MAPLE DUNES ADDITION

FINAL DRAFT

FINAL PLAT

Re: S/D 96-69 -MAPLE DUNES ADDITION (Final Plat)

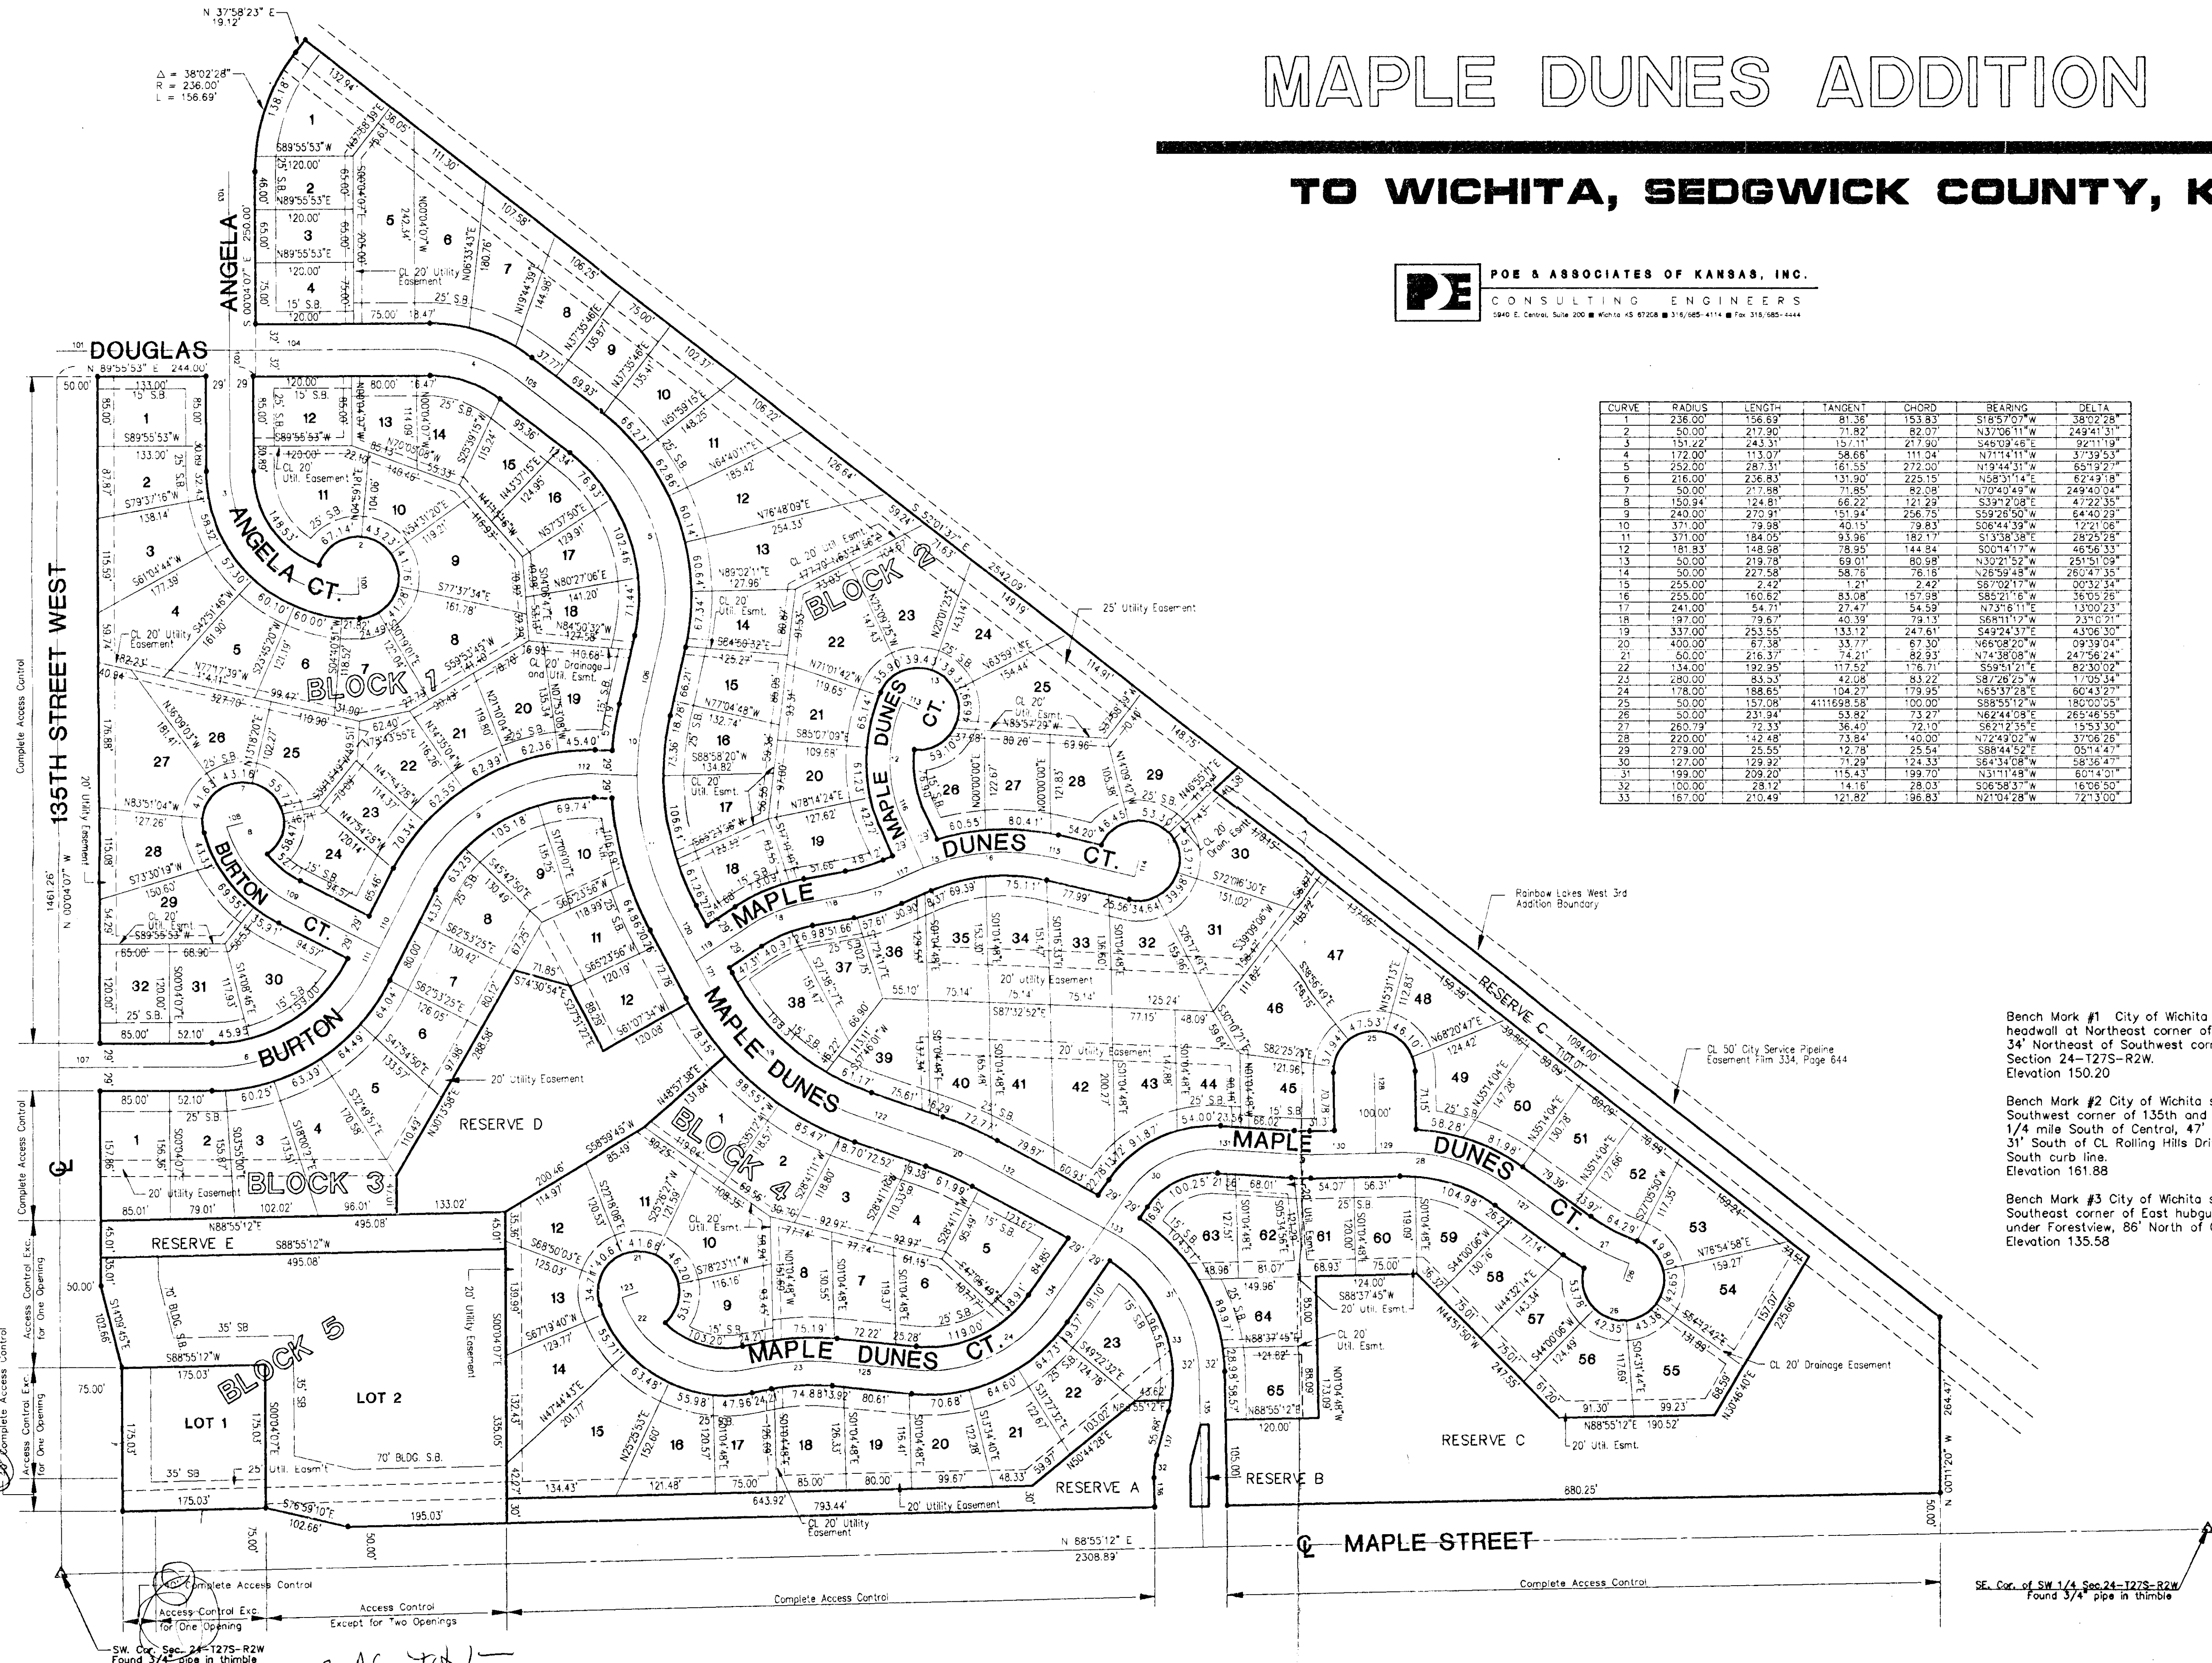
- L. On the final plat tracing, Angela, south of Douglas shall be shown as a Circle and not a Court.
- M. The applicant shall install or guarantee the installation of all utilities and facilities which are applicable and described in Article 8 of the MAPC Subdivision Regulations. (Water service and fire hydrants required by Article 8 for fire protection shall be as per the direction and approval of the Chief of the Fire Department.)

- Q. On the final plat tracing, additional dimensions from lot corners shall be indicated to better locate the easement crossing the rear areas of Lots 1 through 4, Block 3.

- R. In order to increase access to the Reserves of this Addition, particularly Reserve C and D (swimming pool) access easements shall be provided between certain of the lots adjacent to these Reserves. If necessary, the applicant should contact Planning to discuss particular locations.

- S. Since Minimum Building Pad Elevations are being platted for certain lots, such requirements also need to be noted on the face of the plat. Typically, such minimum elevation requirements are at least referenced, just below the north arrow. The elevations may be listed or reference to the plat's text at least made. These elevations need to be shown in both City datum and MSL. Also, as indicated by Engineering, such elevations need to be shown for the other lots adjacent to Reserve C (Lot 30, and Lots 47 through 53).

- T. In regard to access controls as established in the plat's text, the openings associated with Lots 1 and 2, should also include reference to Block 5.

- U. On the final plat tracing, the reference to Reserve C along the northeast line of the plat (Lots 30 and 47 through 53, Block 2) shall be clearly indicated as the area lying between the lots and this plat's perimeter. The wording "Reserve C" should either be placed within this area, or an arrow extending from the present wording in this area.

- V. On the final plat tracing, the reference to the "25 Util.Esm't and Bldg. Setback Line" along the northeast line of the plat shall further note that the Setback Line is a "Bldg. Setback Line for the City Service Pipeline." That is, the setback function of this line is not a platted setback but is rather a private matter controlled by the holder of the pipeline easement.

- W. In terms of the signatures required for this plat, the following changes shall be made on the final plat tracings:
1. all dates shall be changed to 1997.

2. Deputy shall be deleted from the City Clerk's signature block.
 3. The MAPC chairman shall be indicated as John C. Frye.
 4. County signatures shall be indicated as:

- James Alford, County Clerk
 - Larry Consolver, Register of Deeds
 - Michael D. Hurtt, Deputy Register of Deeds.
- X. On the final plat tracing, additional dimensional information shall be provided for the width of the opening (right-of-way) of Maple Dunes at Maple Street and to describe Reserve B at that location.

- AA. As requested by the City's Fire and GIS Departments on the final plat tracing, the street name Douglas shall be placed in the area of Lot 7, Block 2, with Maple Dunes shown from that point southward. The name Maple Dunes shall also be shown just north of the site's entrance off of Maple.
- BB. Also, as noted by City Engineering, oil well equipment, including storage tanks are shown as encumbering easements on certain lots in this Addition. Prior to this plat being scheduled for City Council review, the applicant shall submit a letter indicating that all such structures, encumbrances, etc. have been removed from any area being platted as an easement.
